KANNAD 406 AF-COMPACT

Change in installation configuration

Figure 1: Connector Location

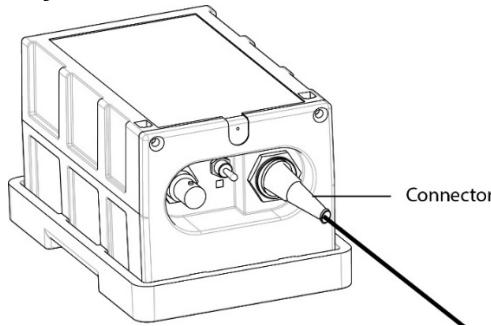
1. If the installation does not include any connector, the installation is correct and does not need to be modified.
2. If the installation includes a connector, refer to the connector label to find its Part Number:

- a. If the installation includes a **DIN 12 connector P/N S1820514-03**, the installation is correct and does not need to be modified.
- b. If the installation includes a **Programming Dongle P/N S1820514-01**, the Programming Dongle shall be replaced by a DIN 12 connector (P/N S1820514-03), following the procedure given in section **3.B Changes to apply for installation including Programming Dongle (P/N S1820514-01)** [page 5](#).
- c. If the installation includes a **Programming Dongle Assembly P/N S1820514-06**, remove the Programming Dongle Assembly of the installation following the procedure given in section **3.C Changes to apply for installation including Programming Dongle Assembly (P/N S1820514-06)** [page 6](#).

Figure 2: DIN12 connector vs Programming Dongle

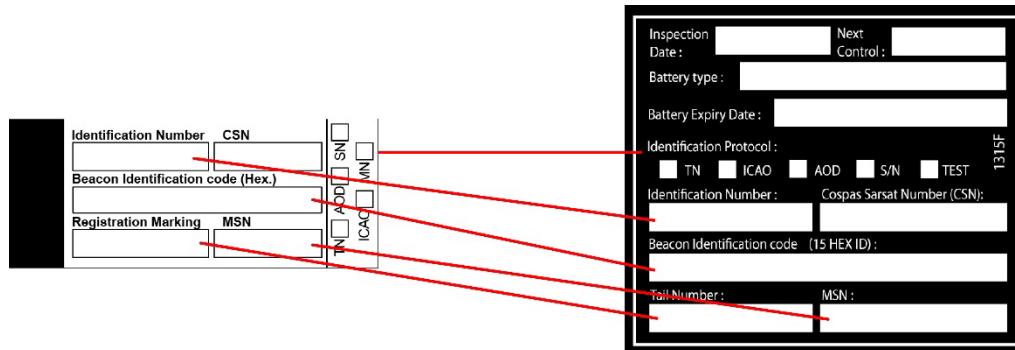
3. If the connector label is missing or unreadable:
 - a. Remove the small screw which holds the metallic body of the connector with a small flathead screwdriver.
 - b. Slide down the metallic body of the connector to remove it.
 - c. Open the small plastic plate.
 - d. If there is no small PCBA inside the connector, it is a DIN12 connector P/N S1820514-03. If there is a small PCBA inside the connector, it is a Programming Dongle P/N S1820514-01. Refer to Figure 2: DIN12 connector vs Programming Dongle.

6. Desolder the Programming Dongle from its cable.

7. Solder a DIN 12 connector in place of the Programming Dongle by keeping the same wirings.

C. Changes to apply for installation including Programming Dongle Assembly (P/N S1820514-06)

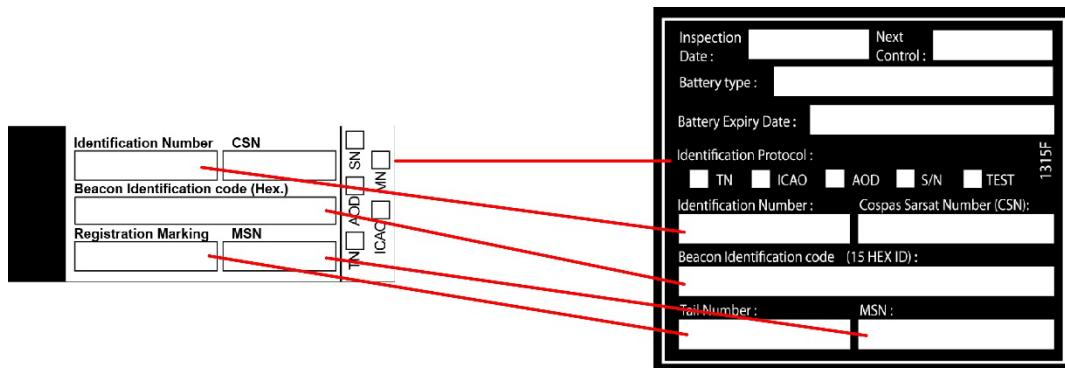
3. Disconnect the Programming Dongle Assembly from the ELT and from the RCP cable.

6. Connect the DIN 12 connector from the RCP cable to the ELT.

NOTE: If the RCP cable is not long enough for connection, the procedure to make a new cable of the correct length is available in the DOC07089 KANNAD 406 AF COMPACT Initial Installation Manual, refer to Appendix B: Extract of the Initial Installation Manual for Wiring. In this case, a DIN 12 connector can be ordered free of charge.

Figure 13: Wiring of 3-wire bundle between RC100 and ELT

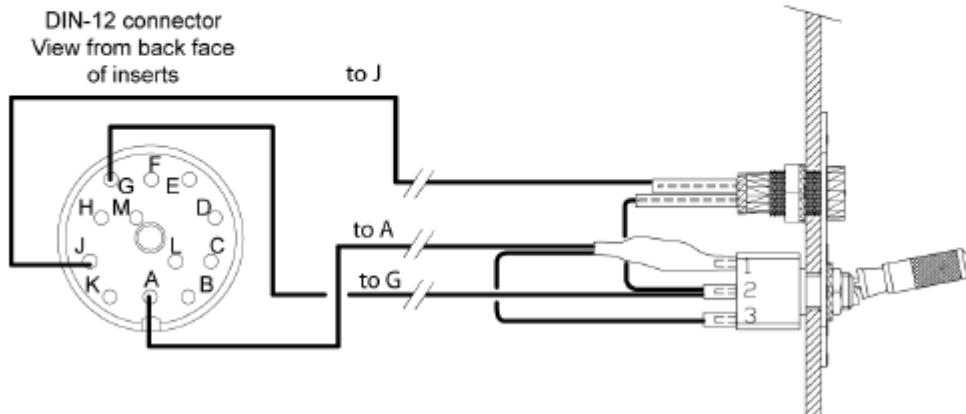
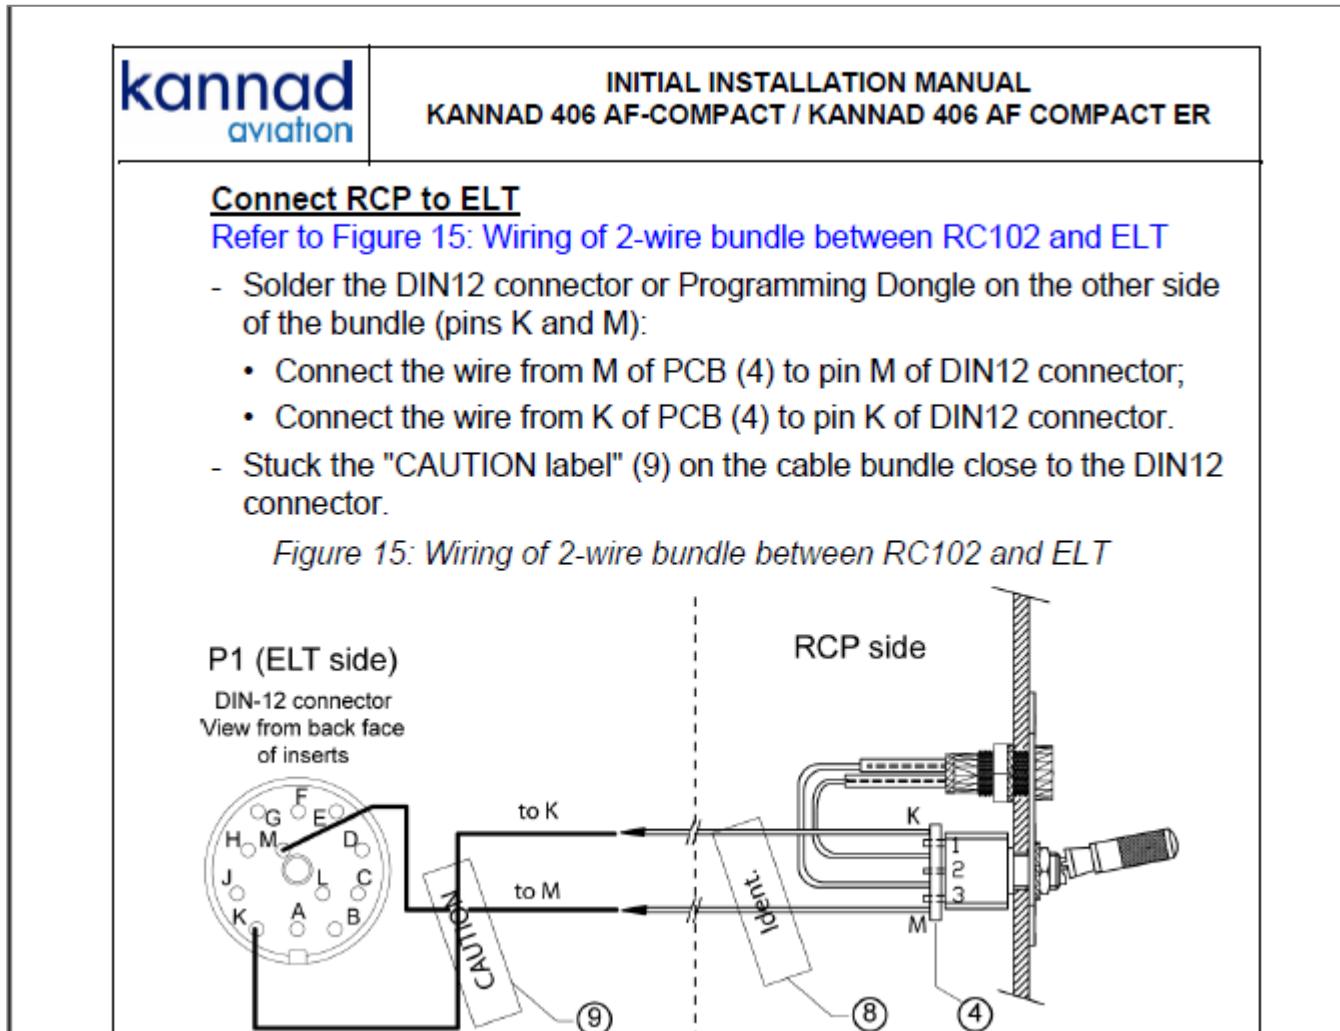
- Solder the DIN12 connector or Programming Dongle on the other side of the bundle (pins A, G, J):
 - Connect the wire from cathode (short leg) of LED to pin J of DIN12 connector;
 - Connect the wire from resistor to pin A of DIN12 connector;
 - Connect the wire from pin 2 of switch to pin G of DIN12 connector.
 - Connect the anode (long leg) of LED to pin 2 of switch.
